# **Appendix 1-C Scott Valley Comment Response Summary**

**Scott Valley Groundwater  
Sustainability Plan Public  
Comment Summary**

Siskiyou County Flood Control and  
Water Conservation District

Stantec Consulting Services, Inc.

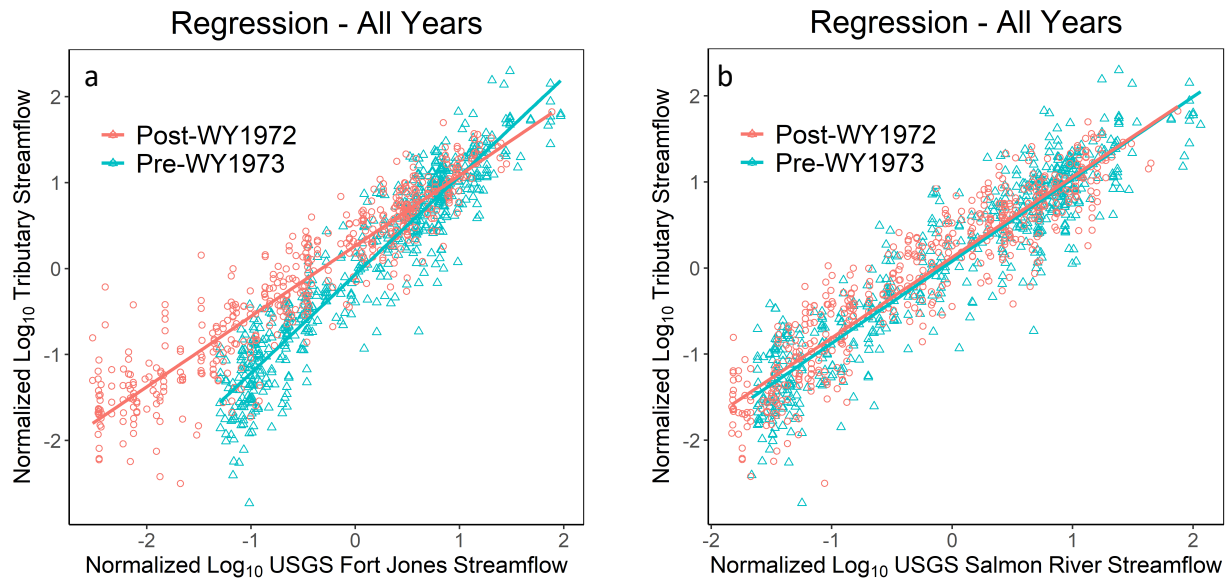
The SVIHM method consists of compiling the available daily flow data for the USGS Scott River at Fort Jones gage (11519500) and ten tributaries, summarizing data to a monthly time step, converting data to normalized log-transformed units (i.e., taking base 10 logarithm, subtracting the mean, and dividing by the standard deviation), developing a linear regression model to predict the tributary flow from the USGS gage data (Figure 2a). Two additional small tributaries (Johnson and Crystal creeks) are assigned flows based on a percentage of estimated Patterson Creek flows.

Scott River summer flows appear to have decreased significantly since the 1977 drought, so the data were split and separate regressions were developed for the WY 1957–1972 and WY 1973–2016 study periods (Figure 1a). For those tributaries that do not have any measured data during the WY 1973–2016 period, the WY 1957–1972 regression is used. Given that there is extremely strong evidence that the relationship between tributary flows and Scott River flows changed between the WY 1957–1972 and WY 1973–2016 periods (i.e., Figure 1a), it does not make sense to apply the WY 1957–1972 regressions without adjusting for that difference. Rather than doing two separate regression models (i.e., one for each period), it would make more sense to just have a single regression model covering all years, but include “Period” as a categorical variable (to account for the difference in intercept between the periods), and an interaction of

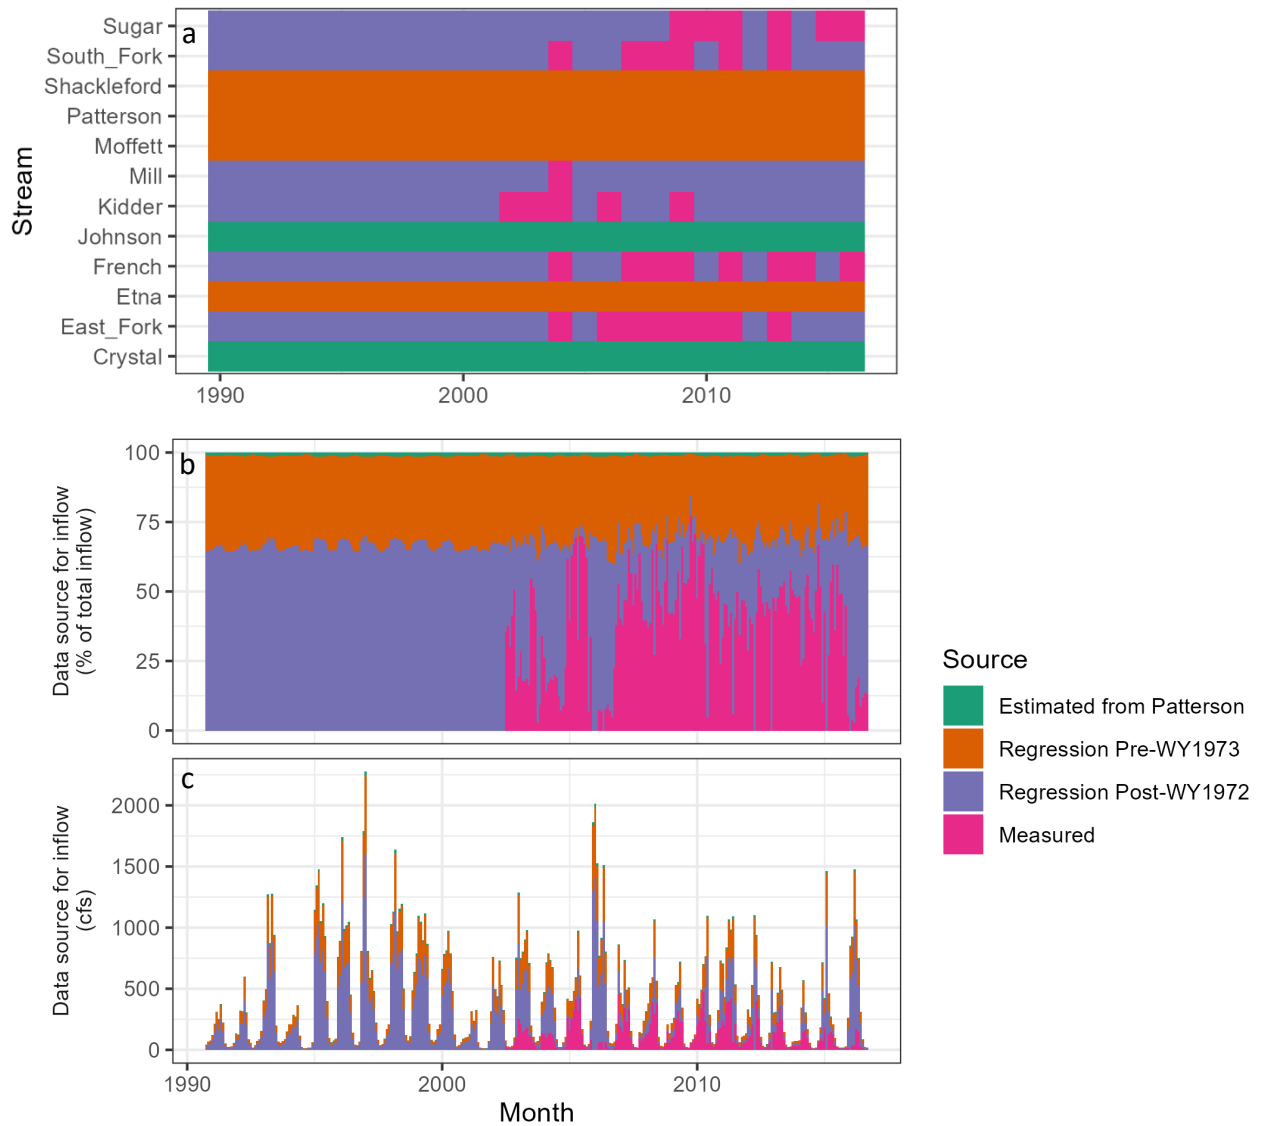
The first thing to recognize about the gap-filling is that gaps are substantial (Figure 2a), so the methods for filling them matters. For the current SGMA GSP, the SVIHM was run for WY1991–2018. Prior to WY 2002, all (100%) of tributaries were estimated using regression against the USGS gage. Since WY 2002, additional gages have been installed but most were operated in only a subset of recent years and now only Sugar Creek and French Creek are still operational (Figure 2). The version of SVIHM used for SGAM did not use any tributary data for 2017-2018. The percent of total estimated inflows in a month that are based on measurements (i.e., gages) only sporadically exceeds 50% (Figure 2b, 2c). The USGS 11519500 gage that is the source for all the regression-based estimates is located at the outlet of Scott Valley. It is problematic to use a gage that is the surface water output of a groundwater basin to estimate the surface water inputs to the same basin, because that groundwater basin exerts profound natural and human influences on hydrology, including water diversions, groundwater pumping, evapotranspiration, groundwater recharge, and leakage of groundwater to streams. In reality, these influences vary not only seasonally (e.g., spring vs. fall) but also inter-annually (i.e., wet years vs. dry years), but using linear regression assumes a constant relationship between the input and output. For example, long-term management changes can affect the relationship between inflows and outflows (i.e., see Figure 1a showing effects of increased groundwater extraction). This gage is also used for calibration and verification of the SVIHM. Given that inflows are an important driver of groundwater dynamics, using the outflow to estimate inflows may artificially inflate the apparent accuracy of the SVIHM (because estimated inflows are automatically scaled based on measured outflows).

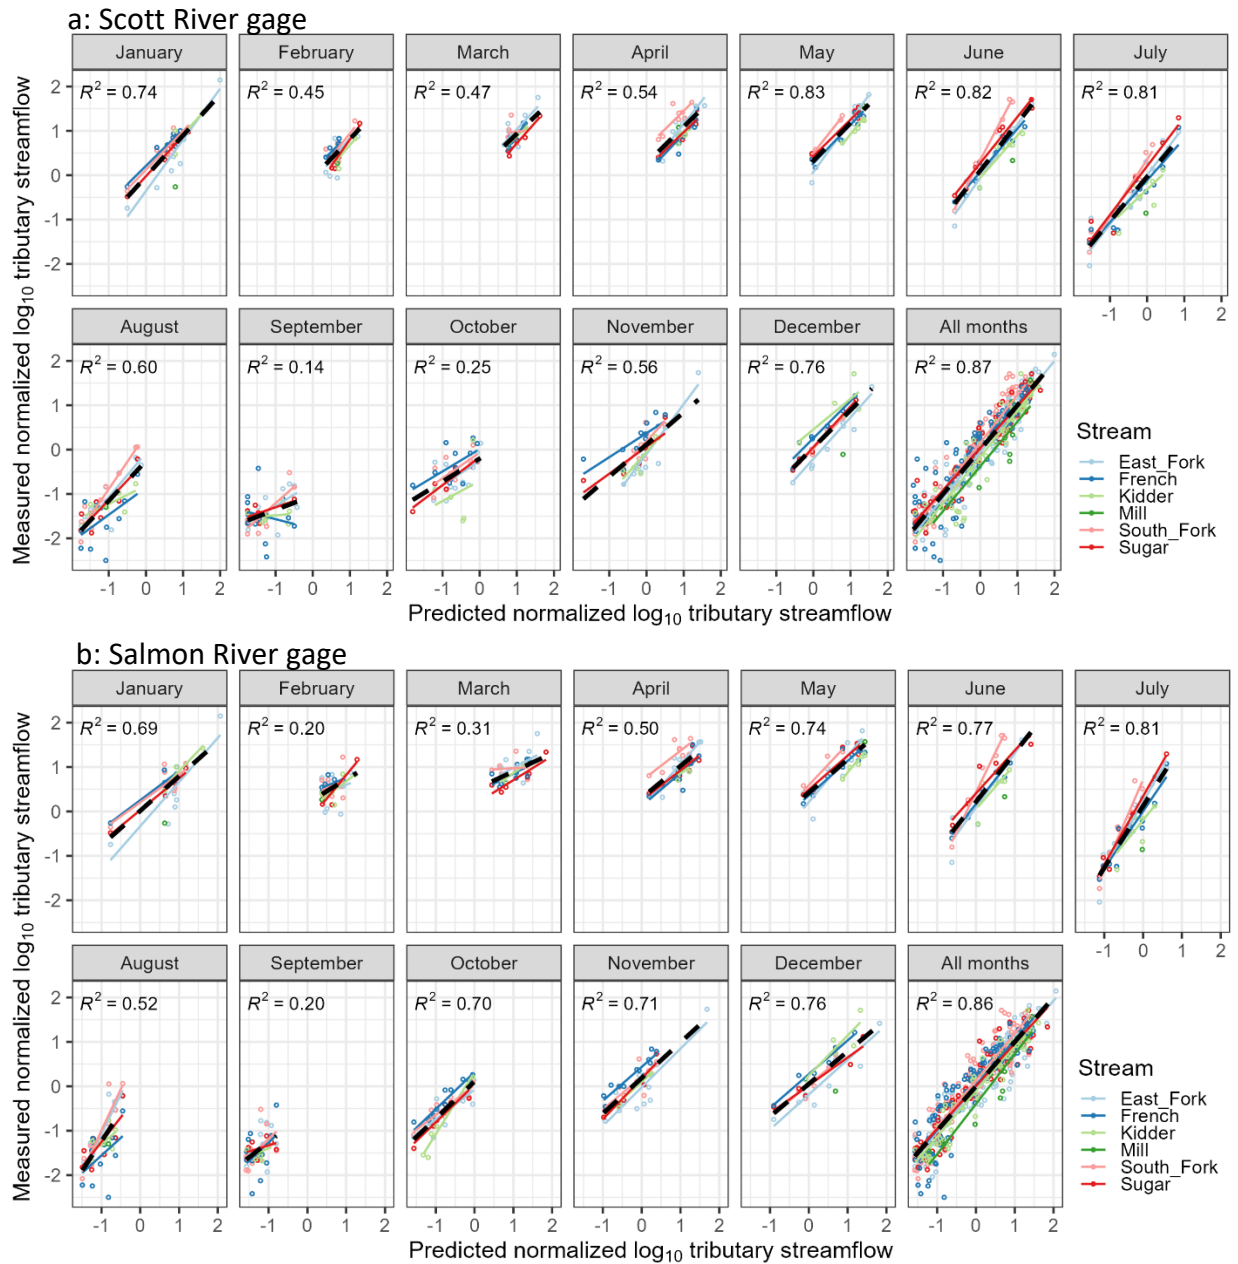
We explored using the USGS gage in the Salmon River at Somes Bar as an alternative to the USGS Scott River at Fort Jones. The Salmon River has several characteristics that make it worth of evaluation for filling gaps in Scott River tributary flows, including: long-term data records, close proximity (i.e., immediately to west) to the Scott River sub-basin, lack of dam regulation, lack of major diversions, and does not contain a large alluvial groundwater basin with intensive groundwater extraction. The Salmon River's relative lack of diversions and groundwater extraction may make it a better choice than the Scott River during the low-flow season. While overall fit for the WY 1973–2016 period is similar for Scott River gage model ( $R^2 = 0.87$ ) and Salmon River gage model ( $R^2 = 0.86$ ), fit varies by month with the Scott River performing better (i.e., higher  $R^2$ , Figure 3b) in January–August and the Salmon River model performing better in September–November (i.e.,  $R^2 = 0.20, 0.70, \text{ and } 0.71$  compared to  $R^2 = 0.14, 0.25, \text{ and } 0.56$ )(Figure 3). Differences are especially strong in October, with  $R^2 = 0.70$  for the Salmon River model compared to  $R^2 = 0.25$  for Scott River model (Figure 3). Based on this evaluation, we recommend using the Salmon River model to fill tributary flow gaps in the months of September–November, which is the period when the groundwater basin begins filling and flows begin rising in response to increased precipitation and decreased evapotranspiration following the hot dry summer and year's lowest flows. This period is biologically important because it coincides with the start of chinook salmon spawning season. We are unclear on the how the poor fit of the Scott River regression model during this period (Figure 3a) affects the simulation of groundwater dynamics and outflows in the SVIHM. Have any sensitivity analyses been conducted to see how sensitive outflows are to inflows during this period?

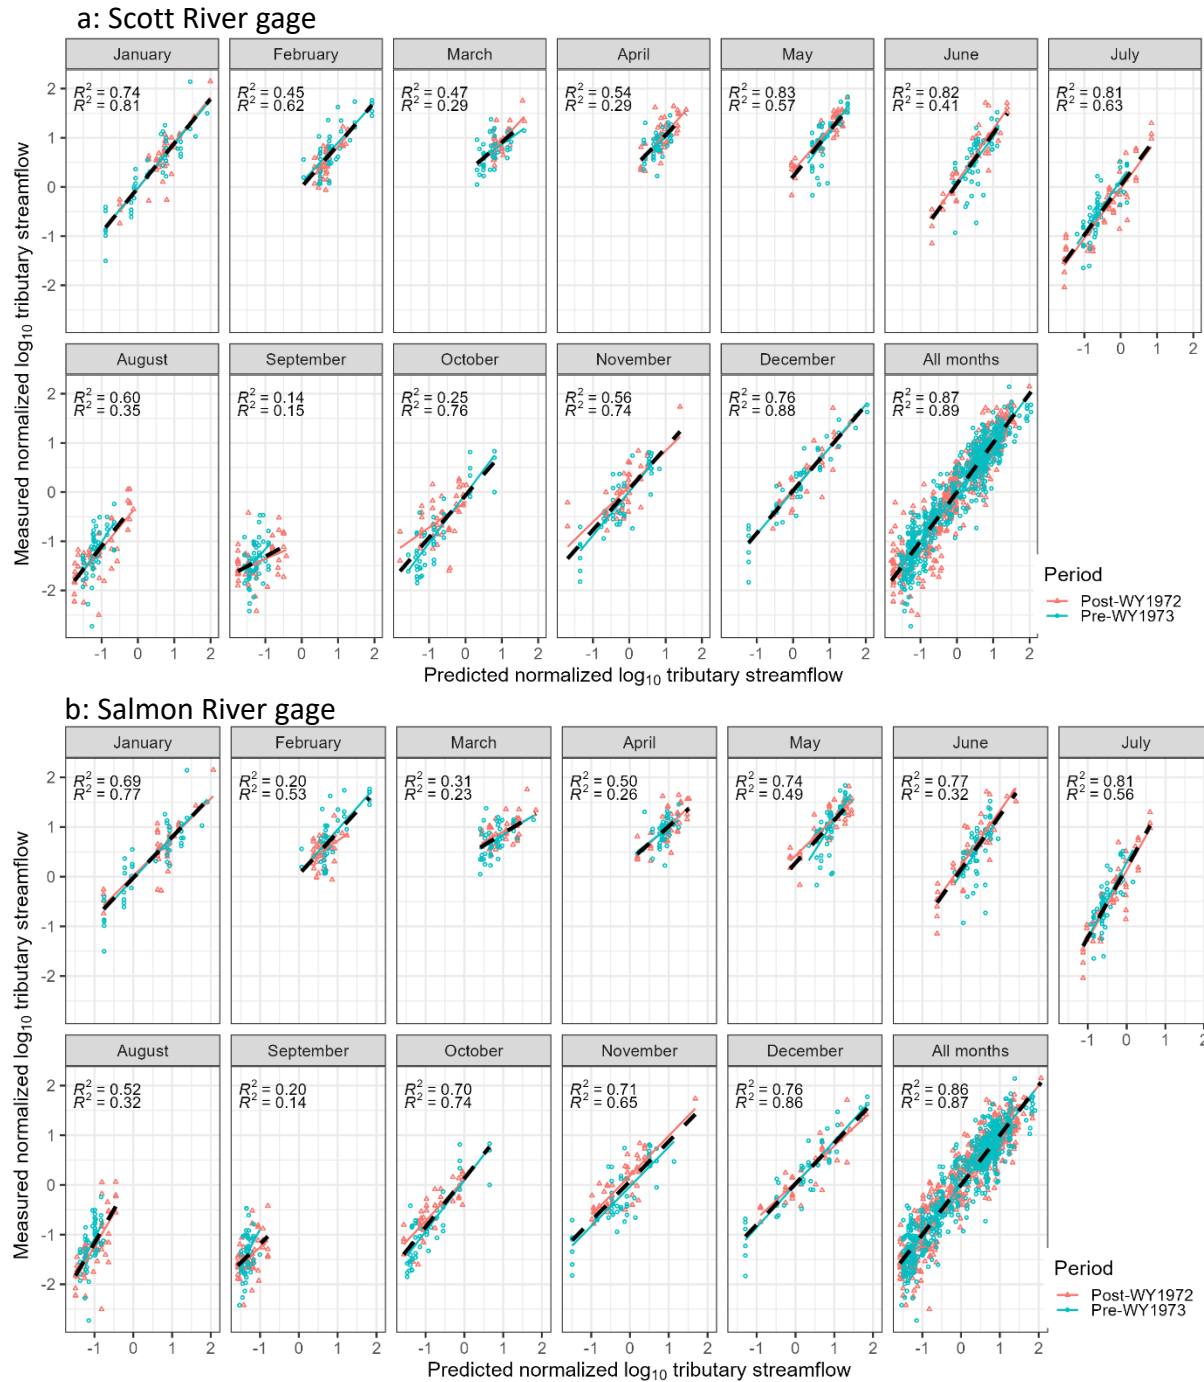
In contrast to the major differences in the relationships between tributaries flows and Scott River flows for the WY 1957–1972 and WY 1973–2016 periods (Figure 1a), there appears to be no difference between the periods when the Salmon River gage is used instead (Figure 1b). The lack of difference between these periods in the Salmon River models suggests that for tributaries that have no post-1972 flow data (i.e., Shackelford, Patterson, Moffett, and Etna creeks)(Figure 2a), it is likely better to use of Salmon River models for gap-filling additional months (i.e., maybe June–December for these tributaries, instead of the September–November we are recommending for the other tributaries?). The recommendation for June–December is based on the observation that the between-period divergence occurs at normalized  $\log_{10}$  Scott River flows less than zero (Figure 1a) and in the WY 1973–2016 period such flows tend to occur more frequently in June–December than other months (Figure 4a).

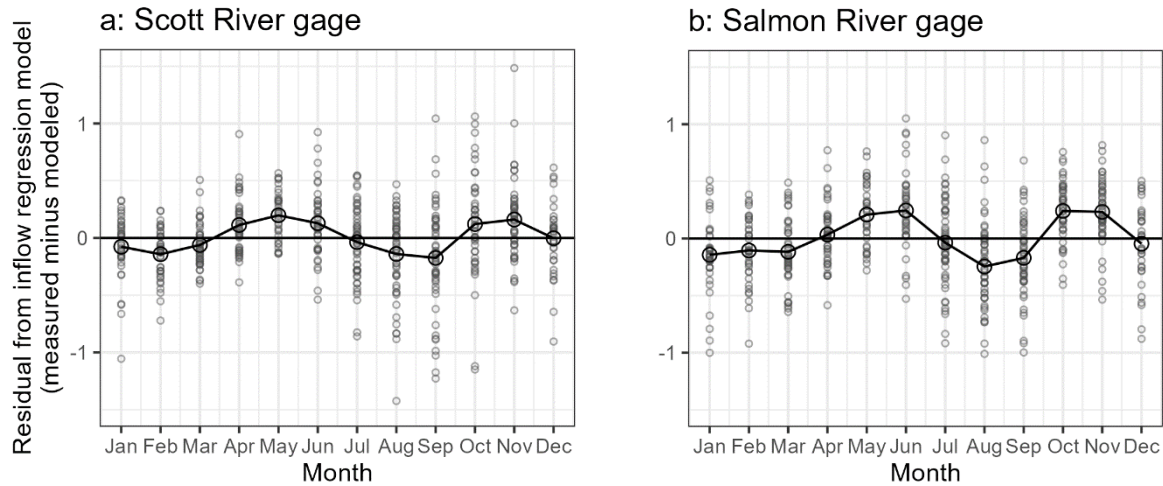
One additional suggestion for potential additional refinements to the methods for filling data gaps that we do not currently have time to test, but want to mention here so it could potentially be followed up on later, is to use hierarchical models and account for watershed area. The SVIHM's normalization (a.k.a. "standardizing", our preferred term) of the flow data (subtracting the mean and dividing by standard deviation, with the mean and standard deviation calculated individually for each site based on that site's period of record) is intended to allow all tributaries to be included together in the same regression model. However, we have some concerns that for sites with short records (e.g., 11 months at Mill Creek, 6 months at Etna and Patterson creeks), there are far too few data points for the mean and standard deviation to be representative of long-term patterns, which could lead to artifacts in the regression outputs. A possibly more robust alternative would be to instead convert the flow data to specific discharge (i.e., flow per watershed area in units of cfs/mi<sup>2</sup> or its metric areal equivalent mm/d), then standardizing by subtracting the mean and dividing by standard deviation (with the mean and standard deviation calculated from the entire pool of specific discharges from all sites, rather than calculating the mean and standard deviation only from each site's period of record). From these standardized specific discharges, a single hierarchical model (a.k.a. mixed effects model) could be constructed with appropriate random effects to explicitly account for inter-site differences. R packages available for implementing such models include 'mgcv', 'lme4', and 'nlme'. A hierarchical model could help account for inter-site differences. For example, not surprisingly given its the relatively low elevation watershed, Moffett Creek appears to have a greater percent of its annual flow occur during January–March than other tributaries and then a lesser percent of its annual flow occurs during May–June snowmelt runoff (not shown here). There are clear, albeit relatively small, seasonal patterns in the residuals (calculated as measured minus modeled) in both the Scott River and Salmon River regression models, with both models under-predicting tributary flows in May–June and October–November and over-predicting tributary flows in January–March and August–September (Figure 5). A hierarchical model would likely help remove the seasonal patterns in model residuals.

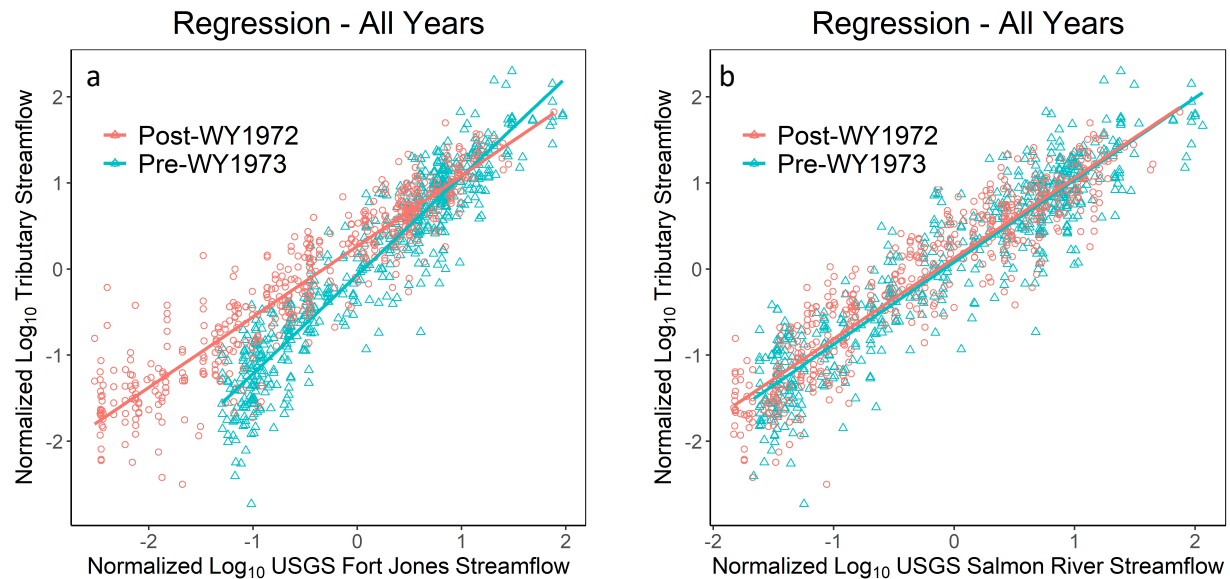
The SVIHM method consists of compiling the available daily flow data for the USGS Scott River at Fort Jones gage (11519500) and ten tributaries, summarizing data to a monthly time step, converting data to normalized log-transformed units (i.e., taking base 10 logarithm, subtracting the mean, and dividing by the standard deviation), developing a linear regression model to predict the tributary flow from the USGS gage data (Figure 2a). Two additional small tributaries (Johnson and Crystal creeks) are assigned flows based on a percentage of estimated Patterson Creek flows.

Scott River summer flows appear to have decreased significantly since the 1977 drought, so the data were split and separate regressions were developed for the WY 1957–1972 and WY 1973–2016 study periods (Figure 1a). For those tributaries that do not have any measured data during the WY 1973–2016 period, the WY 1957–1972 regression is used. Given that there is extremely strong evidence that the relationship between tributary flows and Scott River flows changed between the WY 1957–1972 and WY 1973–2016 periods (i.e., Figure 1a), it does not make sense to apply the WY 1957–1972 regressions without adjusting for that difference. Rather than doing two separate regression models (i.e., one for each period), it would make more sense to just have a single regression model covering all years, but include “Period” as a categorical variable (to account for the difference in intercept between the periods), and an interaction of “Period” and Fort Jones (to account for the difference in slope between the periods). In contrast, the current approach does not take maximum use of the available data, ignoring factors that are known to be important (i.e., the difference between the periods).
